STATE OF NEW HAMPSHIRE INTER-DEPARTMENT COMMUNICATION

PERMIT AMENDMENT North Hampton, 16060

(DES#2015-03249)

North Hampton 16060 Wetland Impact Area Changes

Revised Plan 9/23/16

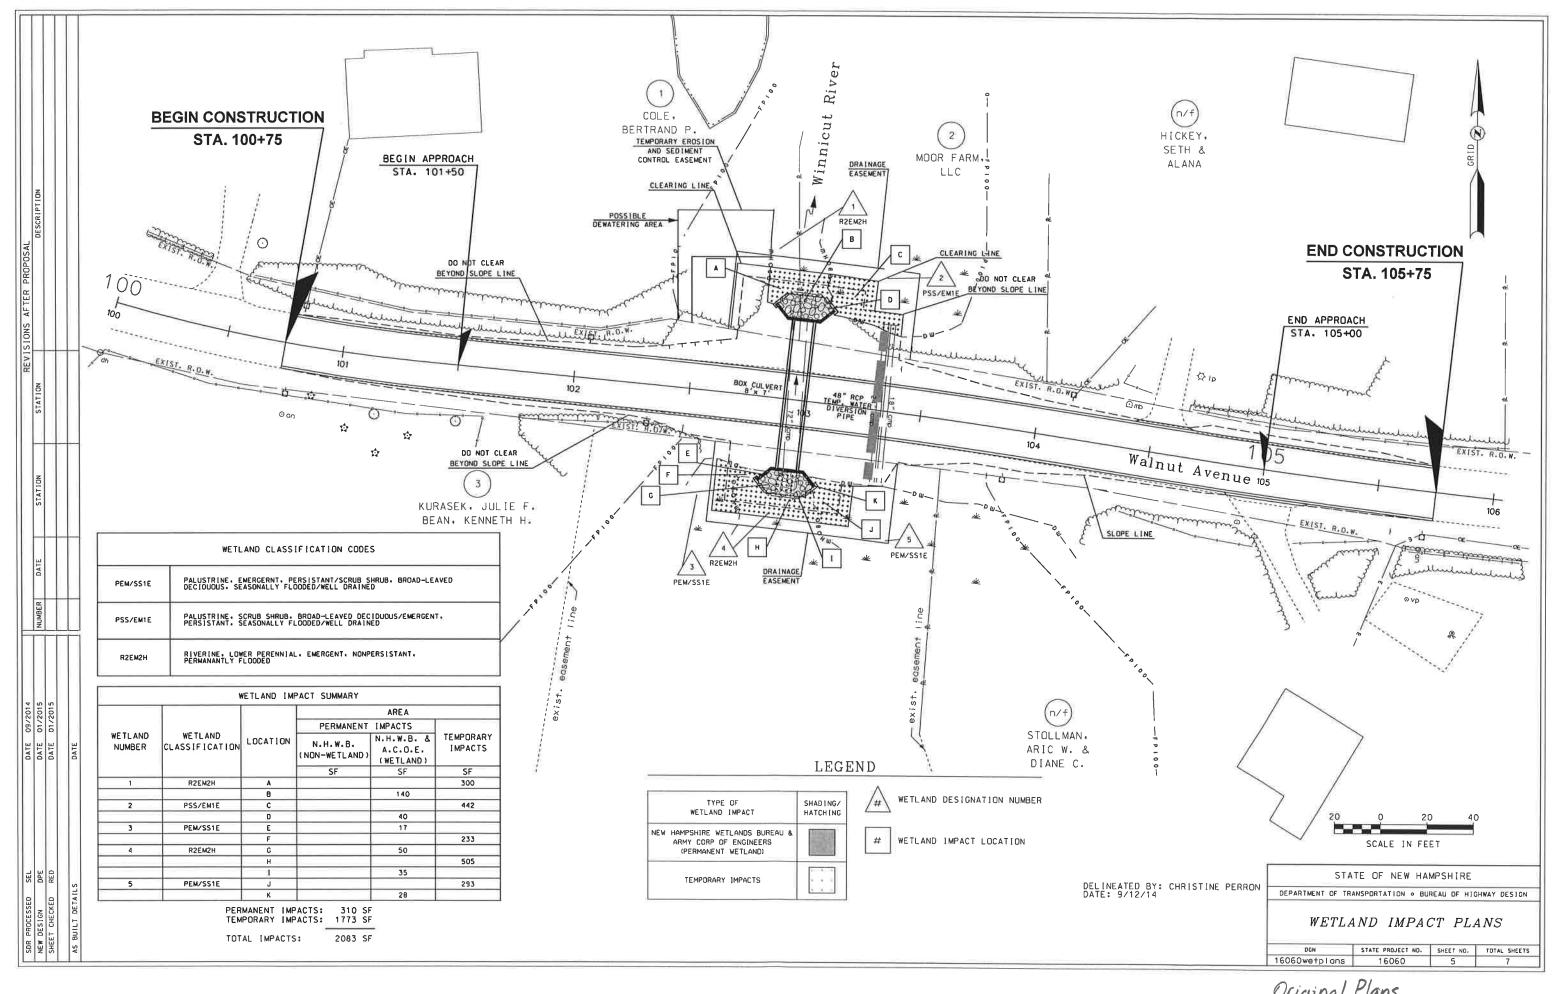
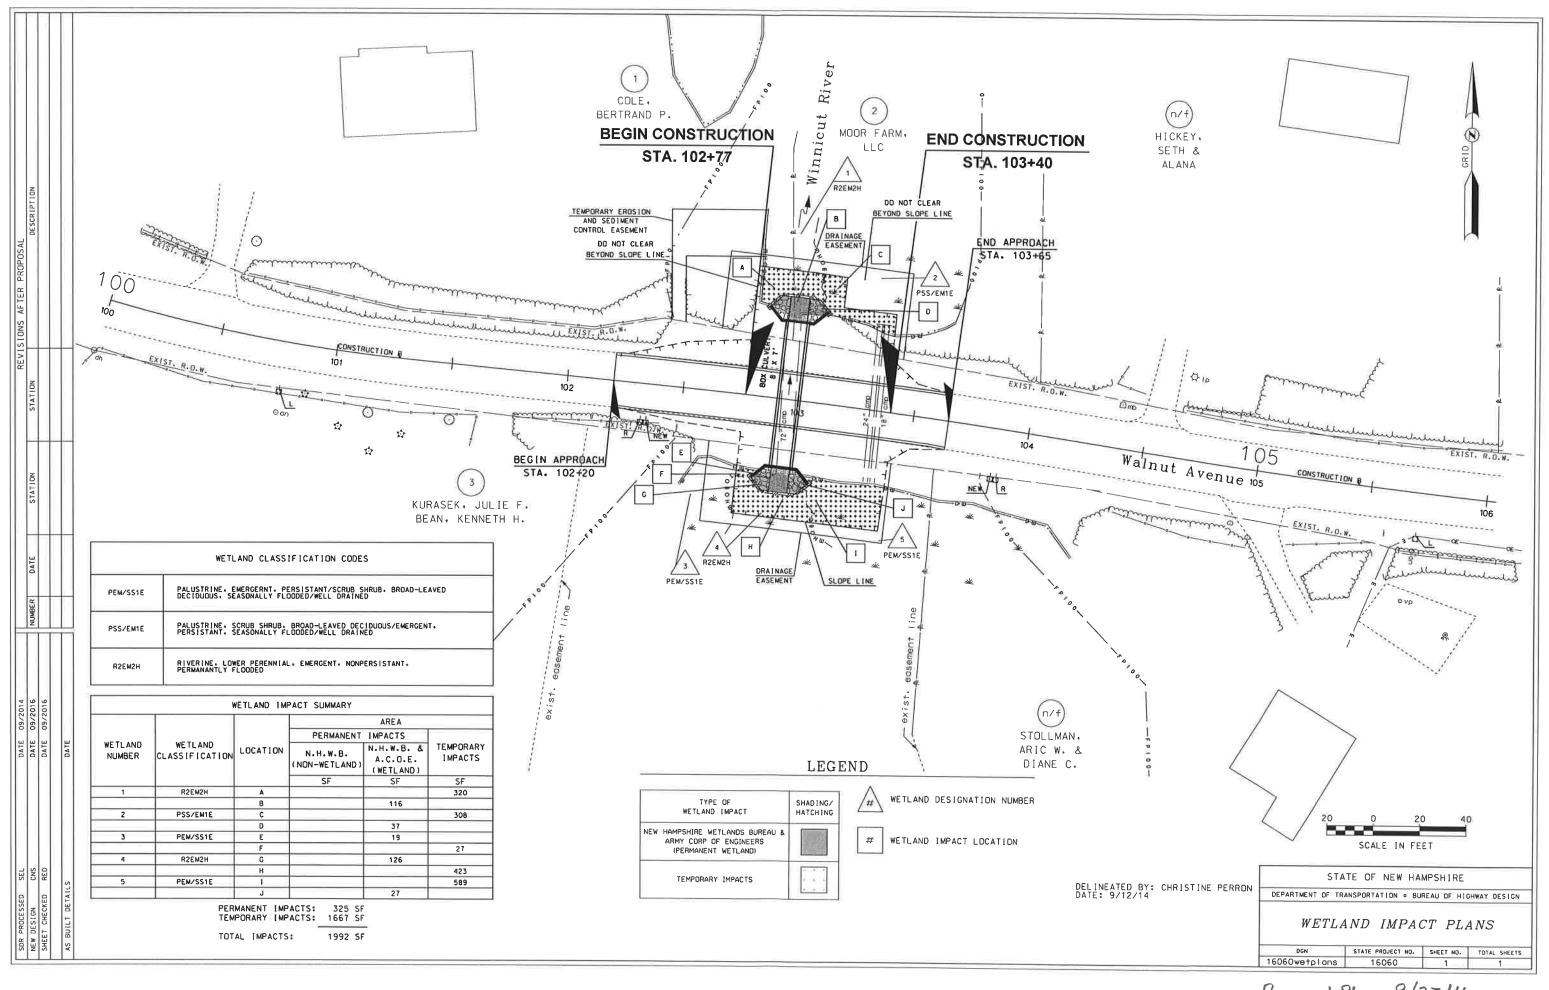
- Reduced Temporary Impact Area C (Sta. 103+25 LT) due to reduced width of excavation for box culvert replacement. (Coffer dams at 14' off center rather than 25')

- Reduced Temporary Impact Areas F and H (Sta. 102+75 RT) due to reduced width of excavation for box culvert replacement. (Coffer dams at 14' off center rather than 25')

- Enlarged Temporary Impact Area I (Sta. 103+25 RT) due to uncertainty of limits of regrading area at inlet of existing culverts to allow for bypass flow.

- Enlarged Permanent Impact Area G (Sta. 103+90 RT) because of oversight of stone work being done. (Now includes area immediately at outlet, which was shown as a temporary impact before.)

- Slight shift for all Permanent Impact areas at inlet and outlet of culvert. This was caused by a drafting error of 1' extra box culvert length on either side. As a result, most areas got slightly smaller because of location of wetland lines within proposed outlet area.
